Well Name: POKER LAKE UNIT 13 DTD	Well Location: T24S / R30E / SEC 24 / NENW /	County or Parish/State:
Well Number: 218H	Type of Well: OIL WELL	Allottee or Tribe Name:
Lease Number: NMNM030453	Unit or CA Name:	Unit or CA Number: NMNM71016X
US Well Number: 3001554474	Well Status: Approved Application for Permit to Drill	Operator: XTO PERMIAN OPERATING LLC

Sundry ID: 2773073

Type of Action: APD Change

Procedure Description: XTO Permian Operating, LLC. respectfully requests permission to make the following changes to the approved APD. These changes include SHL, FTP, BHL and LTP, casing will be downsized and cement changes made accordingly, proposed total depth change and requesting BOP Variance. SHL: FROM: 649' FNL & 2495' FWL of Section 24-T24S-R30E TO: 649' FNL & 2440' FWL of Section 24-24S-30E FTP: FROM: 100' FNL & 2310' FEL of Section 24-T24S-R30E TO: 100' FNL & 990' FWL of Section 24-T24S-R30E BHL: FROM: 50' FSL & 2310' FEL of Section 25-T24S-R30E TO: 10' FSL & 990' FWL of Section 25-T24S-R30E LTP: FROM: 100' FSL & 2310' FEL of Section 25-T24S-R30E TO: 100' FSL & 990' FWL of Section 25-T24S-R30E Proposed TD will change from 20790' MD (Bone Spring) to 20469' MD (Bone Spring) Ca

WELL LOCATION AND ACREAGE DEDICATION PLAT

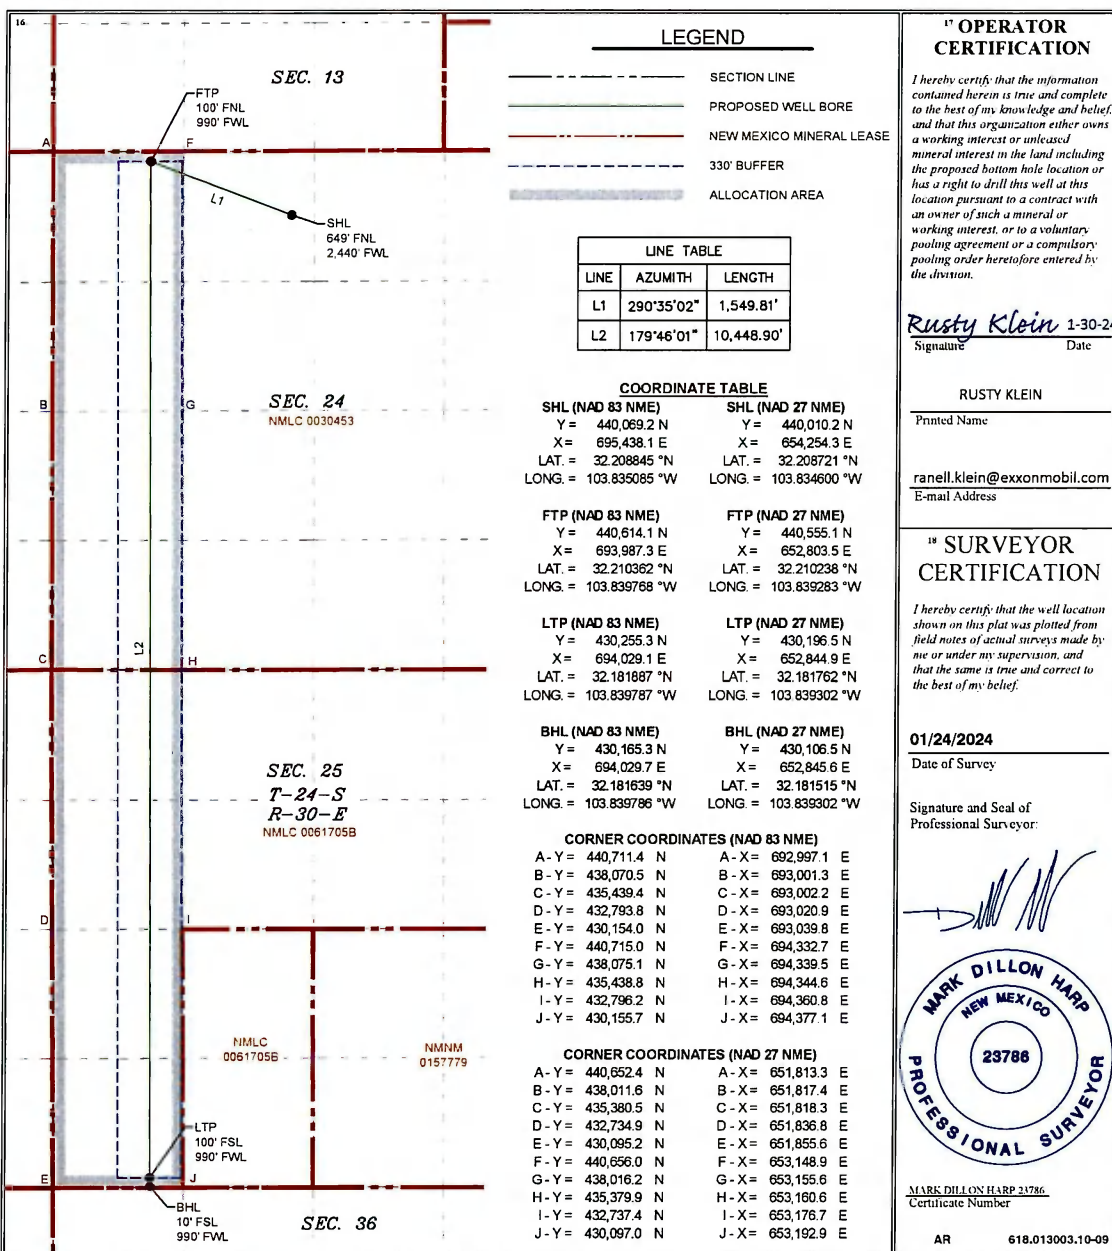
BHL:

FROM: 50 FSL & 2310 FEL of Section 25-T24S-R30E

TO: 10 FSL & 990 FWL of Section 25-T24S-R30E

LTP:

FROM: 100 FSL & 2310 FEL of Section 25-T24S-R30E

TO: 100 FSL & 990 FWL of Section 25-T24S-R30E

Proposed TD will change from 20790 MD (Bone Spring) to 20469 MD (Bone Spring)

UL or lot no.	Section	Township	Range	Lot Idn	Feet from the	North/South line	Feet from the	East/West line	County
C	24	24S	30E		649	NORTH	2,440	WEST	EDDY

UL or lot no.	Section	Township	Range	Lot Idn	Feet from the	North/South line	Feet from the	East/West line	County
M	25	24S	30E		10	SOUTH	990	WEST	EDDY
